FACTORY SERVICE BULLETINS

Engine Performance Complaint from “False Air”

Model 203.040/740

Figure 1

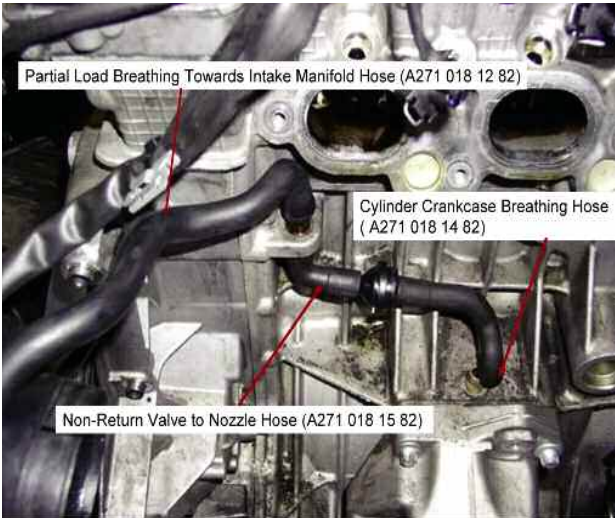
If you receive customer reports in the above model of the engine vibrating, rpm fluctuations at idle or poor accelerator response with codes P2020 (P0172), P2046, P201C or P201A in the engine control unit, please perform the below procedure. The partial load breathing towards intake manifold hose, cylinder crankcase breathing hose or the non-return valve to nozzle hose may be torn at the connection to the crankcase. Air will bypass the air mass sensor, i.e. unmeasured air will enter the intake, causing the engine to run lean.

- 1.Remove compressor (supercharger). Refer to WIS document AR09.50-P-4705QK.
- 2.Remove and inspect the partial load breathing towards intake manifold hose, cylinder crankcase breathing hose and the non-return valve to nozzle hose for crankcase ventilation. If damaged, replace as needed. Refer to Figure 1 for details.
- 3.Install compressor (supercharger). Refer to WIS document AR09.50-P-4705QK.

- Use “click clamp” as specified in parts information for securing hose.
- Ensure that clamp is positioned as close to the end of the hose and fastened tightly.
